## **NOTICE OF A TYPE Ix DECISION ON A PROPOSAL IN YOUR NEIGHBORHOOD**

### **CASE FILE NUMBER: LU 15-230690 LDP**

**Site Address:** 1535 NE JARRETT ST

**Proposal:** The applicant proposes to divide the 5,000 square foot site into two 2,500 square foot parcels for development of detached houses. Water and sanitary sewer services will be provided by existing utilities in NE 16<sup>th</sup> Avenue. Stormwater will be managed by on-site drywells. Access to off street parking will be provided from NE Jarrett Street for Parcel 2 and NE 16<sup>th</sup> Avenue for Parcel 1. The existing house is proposed to be removed.

**SITE PLAN**  
 LOT 4, BLOCK 9, "OAKHURST"  
 IN THE SE 1/4, SECTION 14, T.1N., R.1E., W.M.  
 CITY OF PORTLAND, MULTNOMAH COUNTY, OREGON

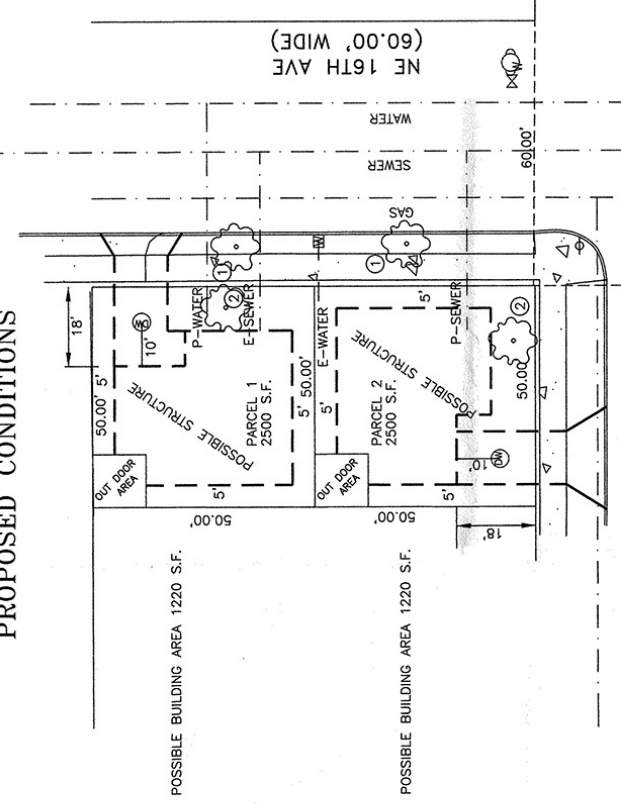
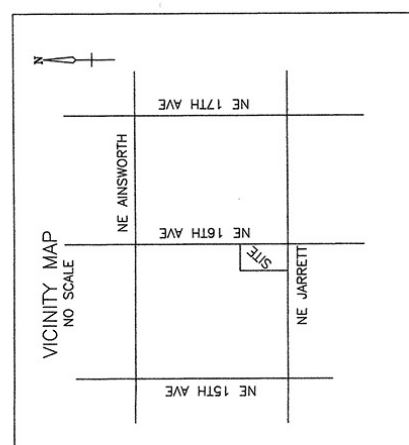
**Findings:** The solar access regulations encourage variation in the width of lots to maximize solar access for single-dwelling detached development and minimize shade on adjacent properties. All of the proposed lots are on the west side of a north-south oriented street. In this case, the lots are oriented to a north-south street, but the widest lots are not the

interior lots. In this case, these criteria are not met. Therefore, Parcel 1 must be revised to be wider than Parcel 2. With a condition of approval requiring this, this criterion is met.

1. To meet the solar access requirements of Chapter 33.639, Parcel 1 must be wider than Parcel 2. The final plat must reflect this condition and can deviate from dimensions shown on Exhibit C.1 provided minimum lot dimension requirements are still met.
